**City of Woodinville
SR 202 Widening and Trestle Replacement Project
Project No. PW ST-13-002
Federal Aid No. HLP-0202(066)
TIB Project No. 8-1-198(006)-1**

**ADDENDUM No. 5
dated
August 13, 2026
to
Contract Documents and Plans**

DATE: 6/16/2026	CHECKED BY: BK
DESIGNED BY: SD	PROJECT NO.: ST-13-002
DRAWN BY: SD	SCALE: VARIES
SHEET 131A OF 172	
DRAWING NO.: L48

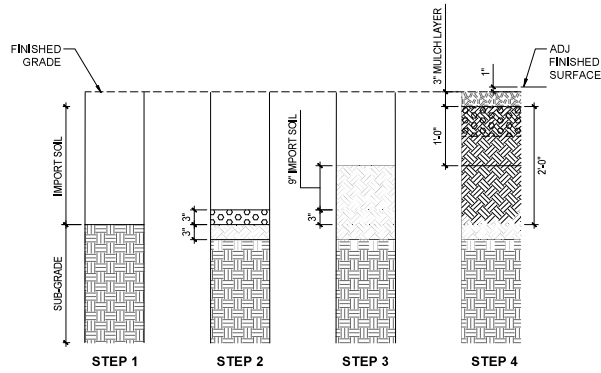
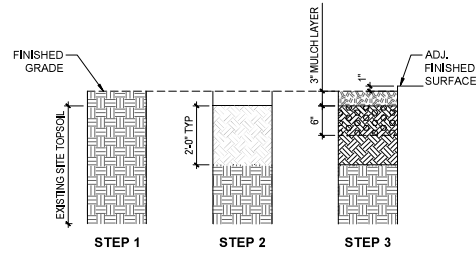
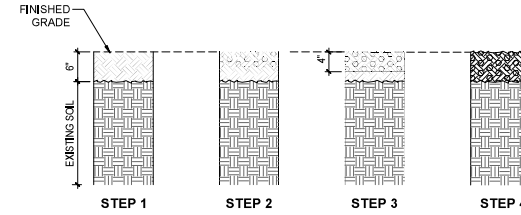
- 3.) **Plan Sheet 131A, Drawing No. L48:** New plan sheet updated soil preparation details

1 | SHRUB AREA SOIL PREPARATION (TOPSOIL TYPE A)

2 | SHRUB AREA SOIL PREPARATION (TOPSOIL TYPE B)
